**TOWN OF PORTOLA VALLEY  
ARCHITECTURAL AND SITE CONTROL COMMISSION (ASCC)  
Monday, November 28, 2016  
7:00 PM – Regular ASCC Meeting  
Special Field Meeting (time and place as listed herein)  
Historic Schoolhouse  
765 Portola Road, Portola Valley, CA 94028**

4. Old Business:
  - a. Architectural Review and Site Development Permit review for three parcels located at 1260 Westridge Drive, Carano Residences (Staff: C. Richardson)

**FROM:** Cynthia Richardson, Planner

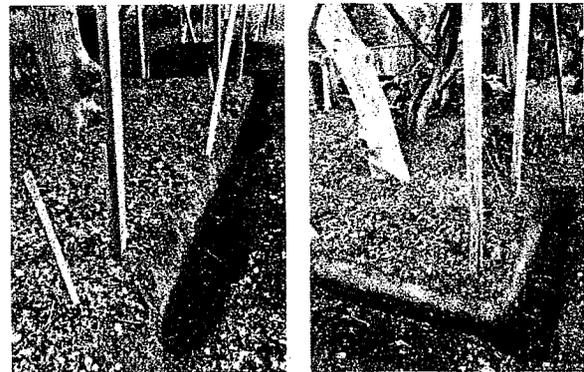
It was my assignment to review the Oaks surrounding the proposed garage plans for Lot C (LC.6 11/10/16) and comment on the effect on the trees.
